REV.
E

AS3321

STUD - STRAIGHT, RING LOCKED,
 CRES AMS5731
 .3125-18UNJC X .3125-24UNJF

ISSUED 1979-09 REAFFIRMED 2001-11 REVISED 2014-07

FIGURE 1 - STUD

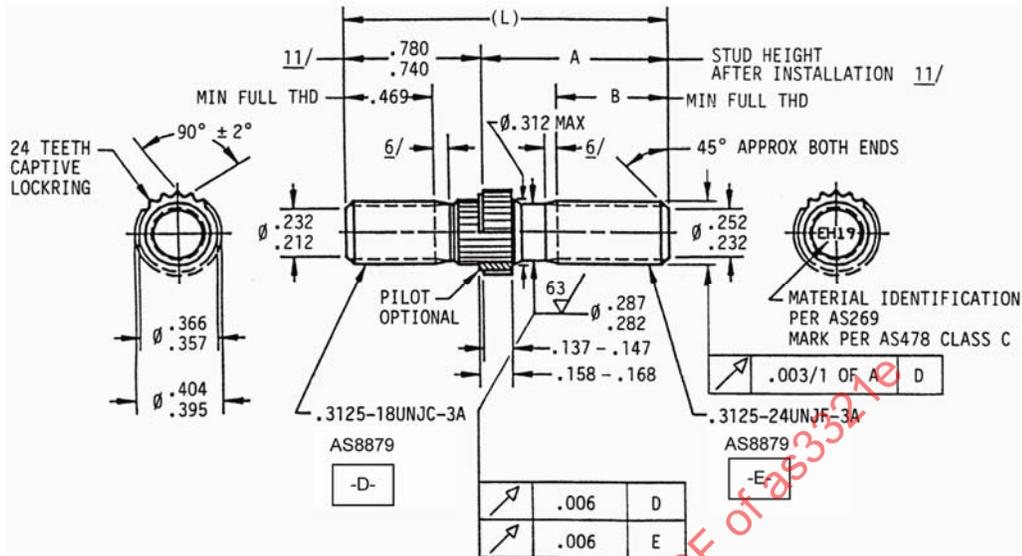
THIS IS A LIMITED SCOPE REVISION. HARDNESS REQUIREMENT IN DRAWING NOTE 3 IS CLARIFIED TO APPLY TO THE STUD ONLY.

- MATERIAL: STUD - CORROSION AND HEAT RESISTANT STEEL, AMS5731, AMS5732, AMS5734, AND AMS5737. (UNS S66286)
LOCKRING - CRES, AMS5640. (UNS S30300)
- HEAT TREATMENT: STUD - SOLUTION AND PRECIPITATION HEAT TREATED. SEE PROCUREMENT SPECIFICATION.
- HARDNESS: STUD - 24-37 HRC, 247-344 HB, OR 260-363 HV.
- FINISH: STUD AND LOCKRING - CLEAN (PASSIVATE) PER PROCUREMENT SPECIFICATION OR PASSIVATE PER AMS2700, METHOD 1, CLASS 4.
- FLUORESCENT PENETRANT INSPECTION: ASTM E1417, EXCEPT LOCKRING. ACCEPTANCE CRITERIA PER AS7482.
- PROCUREMENT SPECIFICATION: AS7482, EXCEPT STRESS RUPTURE TEST IS WAIVED, AND SPECIAL STUD END THREAD REQUIREMENTS OF AS3062 ARE NOT APPLICABLE. INCOMPLETE LEAD AND RUNOUT THREAD REQUIREMENTS ON BOTH THREADS SHALL BE AS SPECIFIED IN AS3062 FOR BOLTS.
